# MONITORING YEAR 2 ANNUAL REPORT

## SHAKE RAG MITIGATION SITE

Madison County, NC  
DEQ Contract No. 7190  
DMS Project No. 100018  
USACE Action ID No. SAW-2017-01570  
DWR Certification No. 17-1157

RE: Shake Rag Mitigation Site – Monitoring Year 2 Report Response to DMS Comments  
French Broad River Basin – CU# 06010105 – Madison County  
DMS Project ID No. 100018  
Contract # 7190

Figure 3.2 Monitoring Plan View Map  
Shake Rag Mitigation Site  
DMS Project No. 100018  
Monitoring Year 2 - 2021

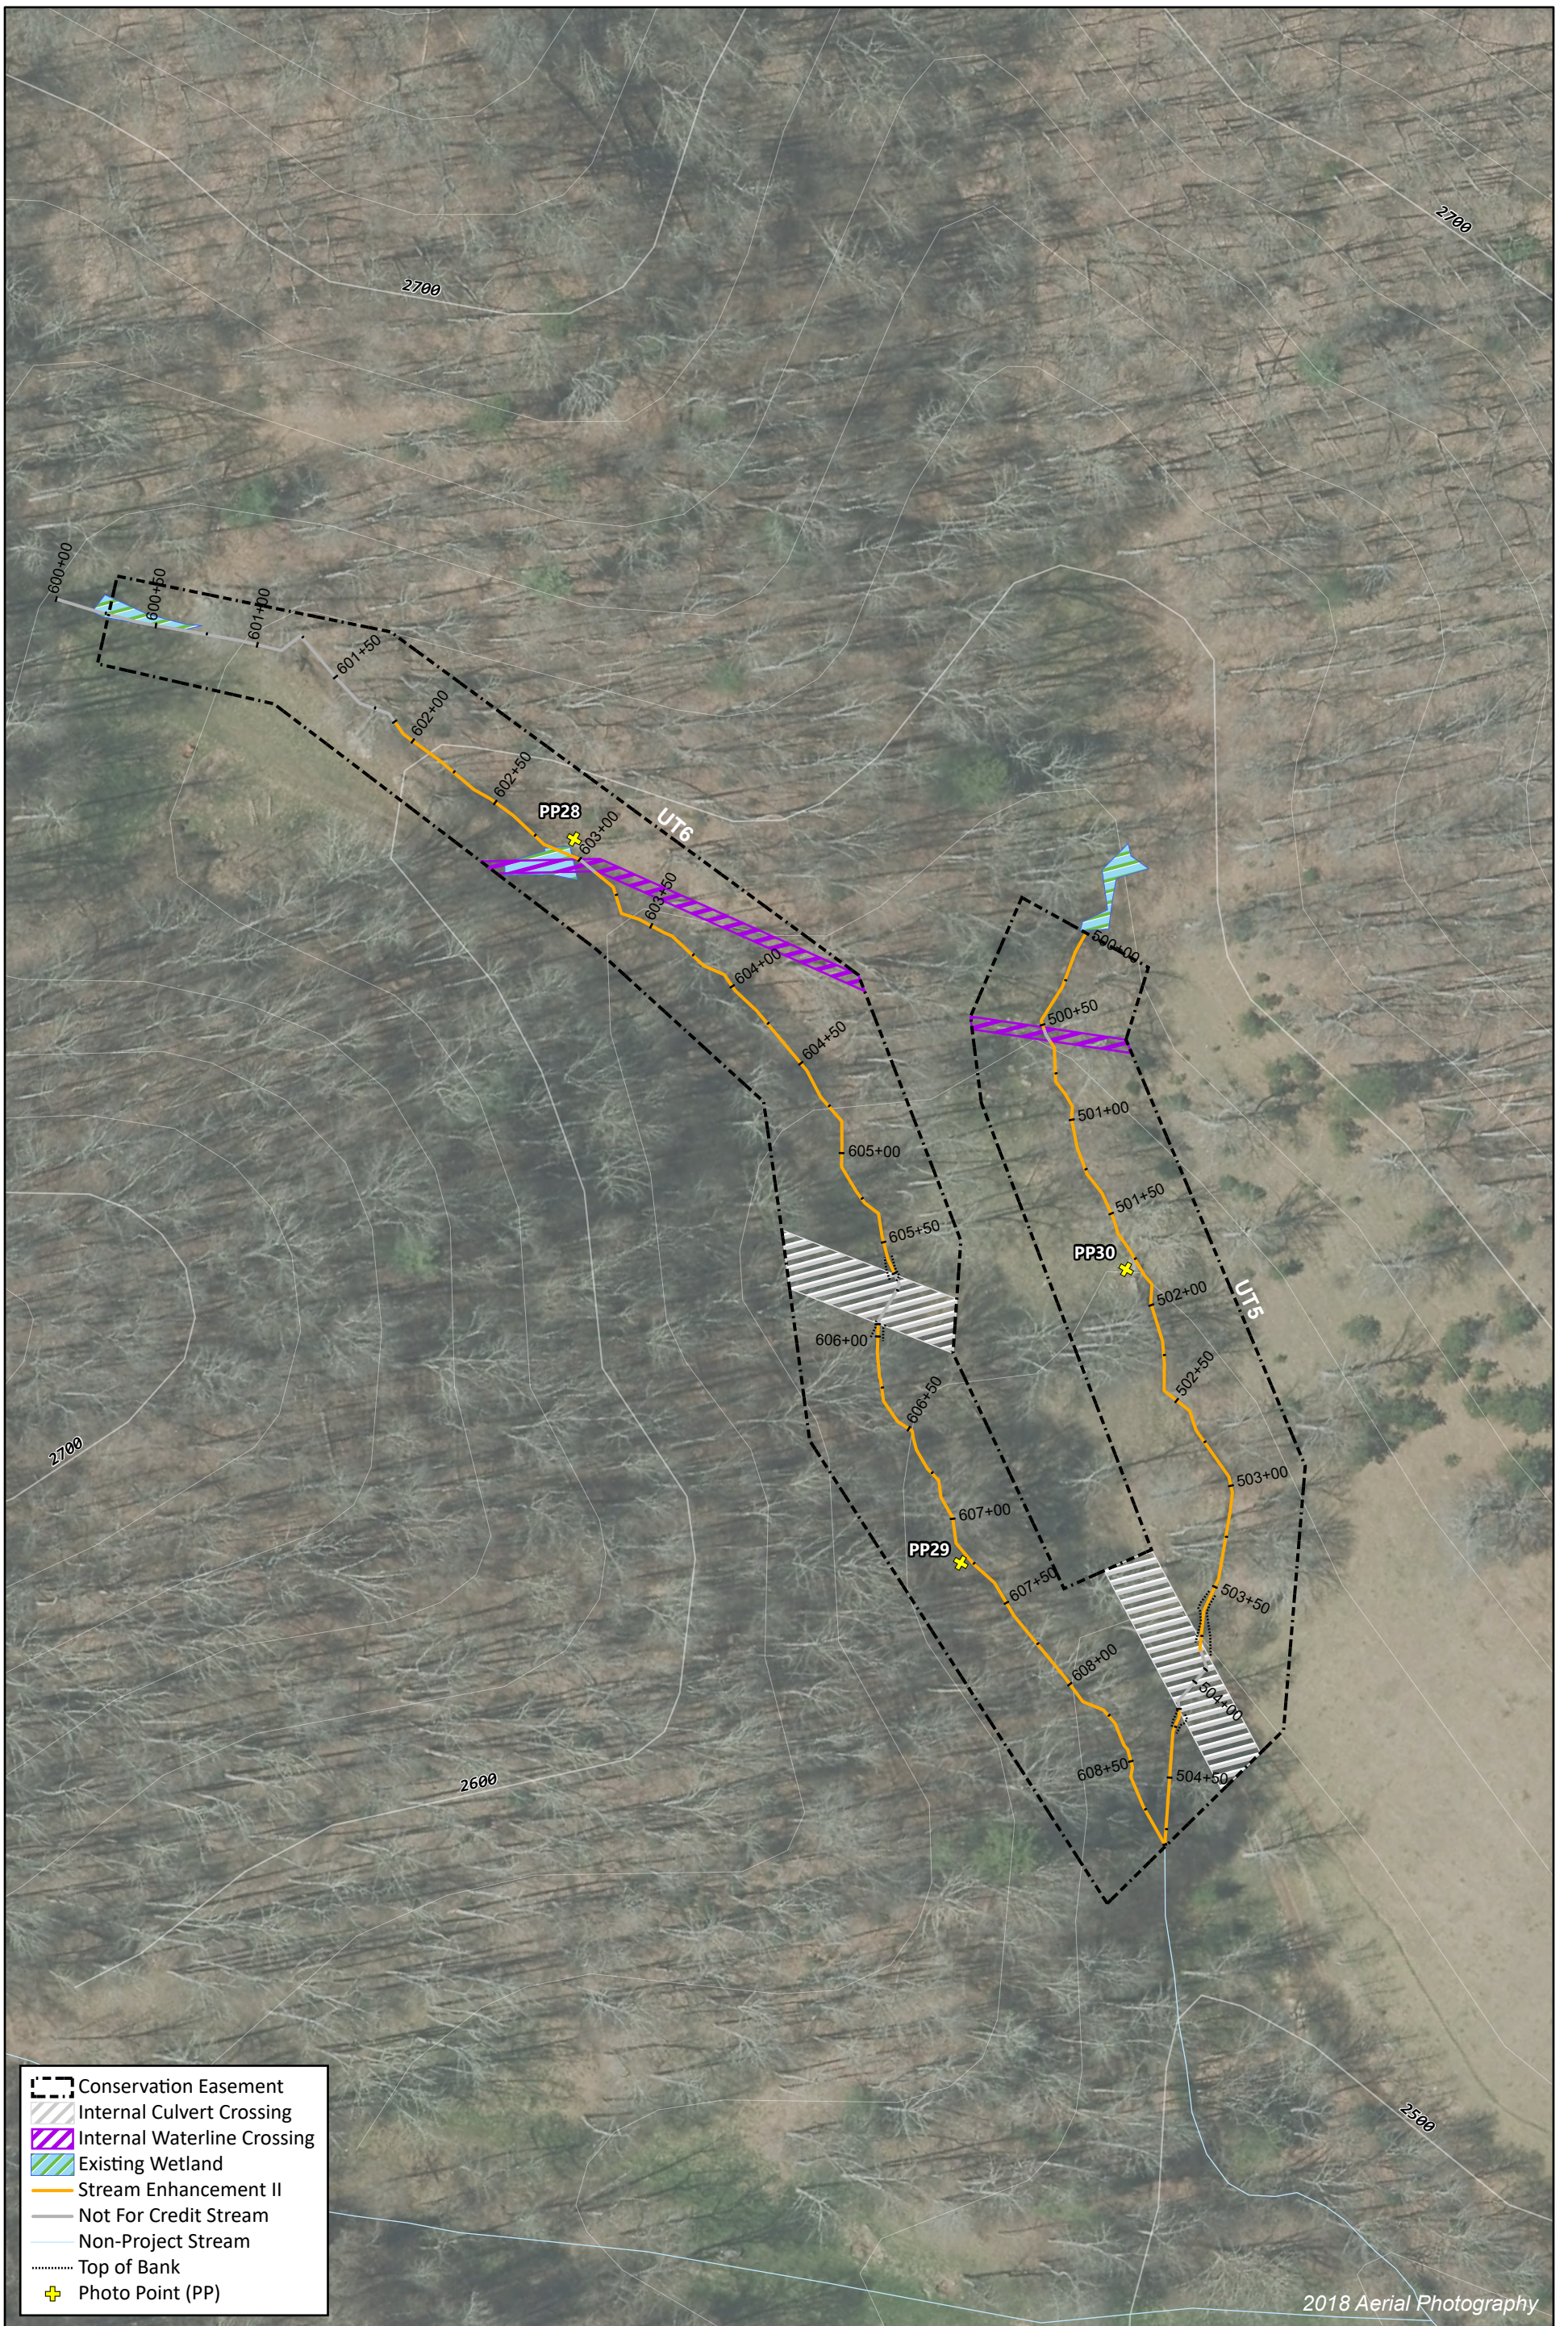
**DMS' comment: Section 1.2.5 should describe and reflect what is shown on the CCPV. Please revise this section with the level of detail necessary to inform reviewers of site conditions. Please quantify and describe problem areas. Include number, locations, type (rock/log) of piping structures, length and locations of eroding banks, etc. The text describes "reconfiguring boulders and riffle stone around problematic structures", but Table 6 lists engineered structures as functioning at 100% the majority of the time. Please review and revise the CCPV and Table 6 as necessary.**

**DMS' comment: There are 11 headcuts shown on the CCPV and not discussed in the report. Please add a discussion of these areas in the report.**

*Wildlands' response: Text has been added to Section 1.2.5 to better quantify and describe the areas of concern. An additional appendix (Appendix 6) has also been added with a table summarizing locations, type, length (if applicable), and planned management activity by stream reach. The majority of the issues identified as "headcut/downcutting" on the CCPV figures are located within sections of cascading riffles (as shown on the Shake Rag Record Drawings from as-built) that include many drops and riffles. Therefore, a few instances of "headcut/downcutting" associated with structures within the cascading riffle sections did not seem to warrant the failure of the entire cascading riffle since it's counted as one structure in the engineered structures category in Table 6.*

*Wildlands' response: Text has been added to Section 1.2.5.*
